Latton Priory, part of the Harlow and Gilston Garden Town

This brochure explains the engagement process, public consultation feedback and how this has been taken into account as the SMF has evolved. Following formal consultation and extensive review and scrutiny by the council, professional team and HGGT partners, the SMF has been endorsed by EFDC, and can be taken into account as an important material consideration in the determination of future planning applications.

Updated Illustrative Masterplan

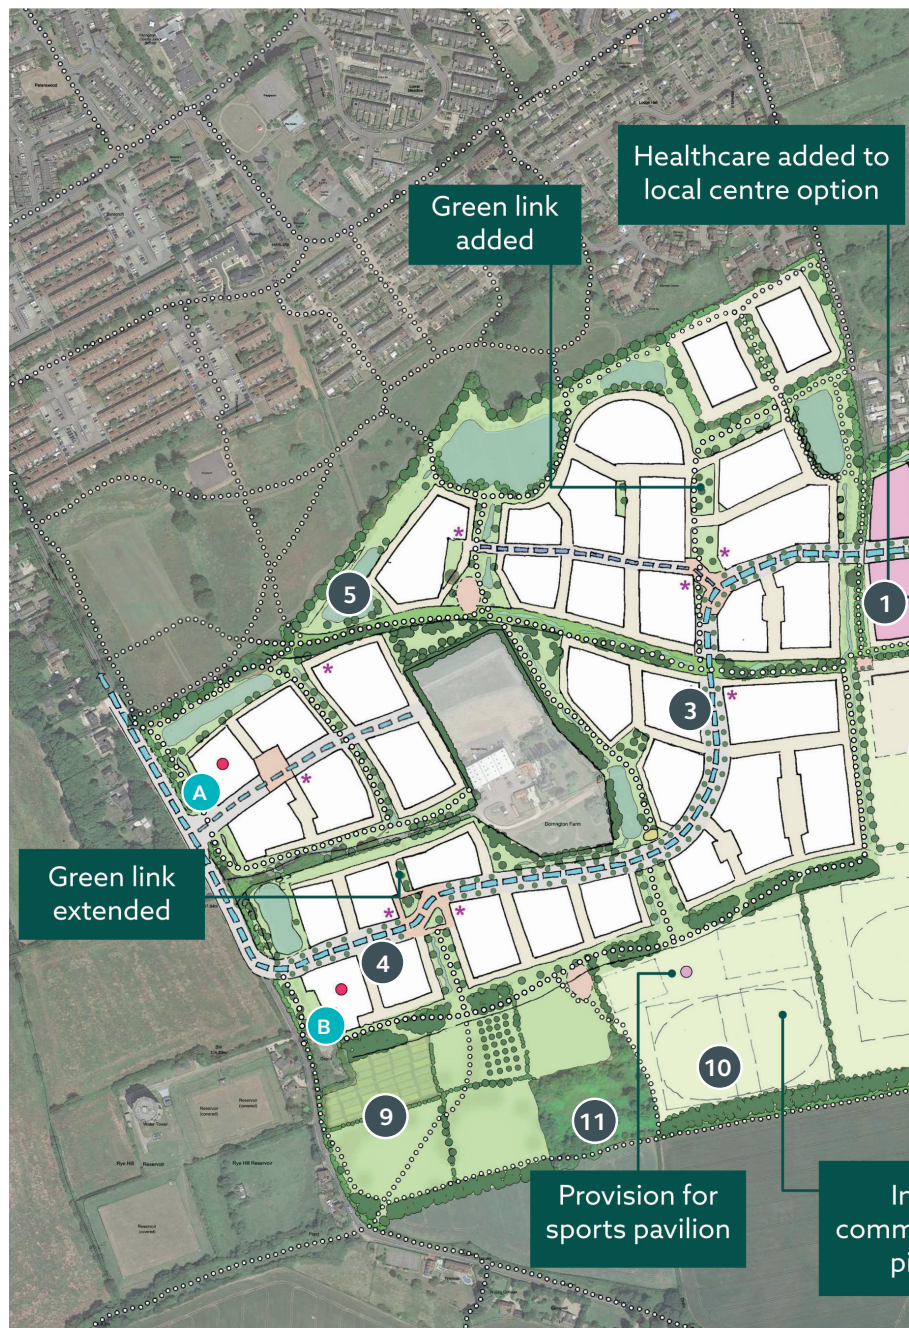
New greenway routes should run around the perimeter of the sports ground rather than through the centre of it.	The greenway route that passes between the pitches on the masterplan / Green Infrastructure (GI) plan has been removed. A route is already provided along the western edge of the pitches which connects with an east west route to the south.
Can the amenity grass proposed to the west of the sports pitches be designed so that it could be used in the future for additional sports pitches as well as informal recreation (as the principal use) if required by the community? The space would need to be sufficiently level and free of footpaths, trees and other constraints to facilitate potential sports pitch use;	The adjacent field to the west is proposed as an amenity grass kickabout area and will be suitably level by virtue of its position on the plateau landform. It can therefore easily be marked out as a mini football pitch if required.

Increased community sports pitch area

The feedback has been reviewed in depth and there has been further collaborative work between the developers (CEG and Hallam Land Management), EFDC and HGGT team, in order to update and finalise the Strategic Masterplan Framework for endorsement by EFDC.
